OFFICE OF PLANNING AND ZONING

CONFIRMATION OF PRE-FILE

PRE-FILE #: 2025-0100-P
DATE: 10/30/2025
OPZ STAFF: David Russell
Subhash Dhir

SITE LOCATION: 525 Overhill Drive

LOCATION DRAWING OF
#525 OVERHILL DRIVE
LOT 11 BLOCK I
HOLLY HILL HARBOR
PLAT BOOK 89, PLAT 43
ANNE ARUNDEL COUNTY, MARYLAND
SCALE 1"=40' DATE 11-06-2024
DRAWN BY AP FILE # 2410133-805

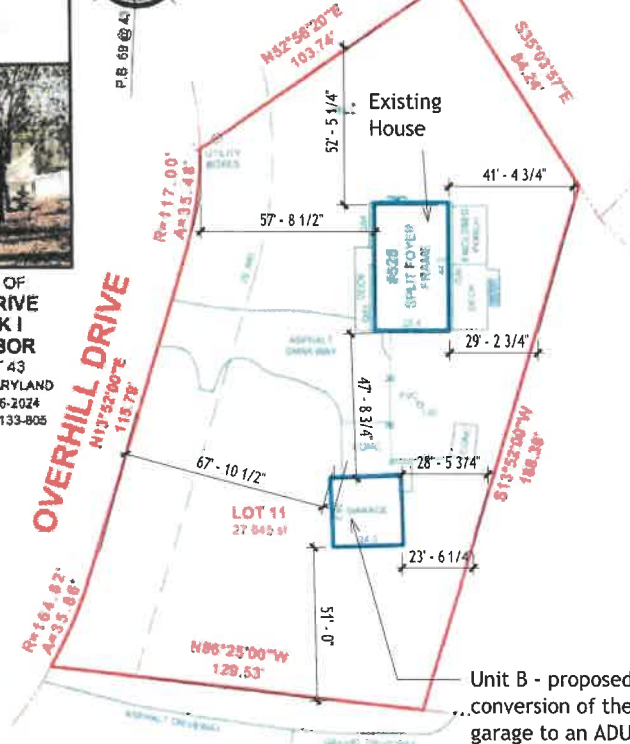
On the site plan, please ensure all dimensions and pertinent information are legible. In particular, please provide more legible dimensions for the garage.
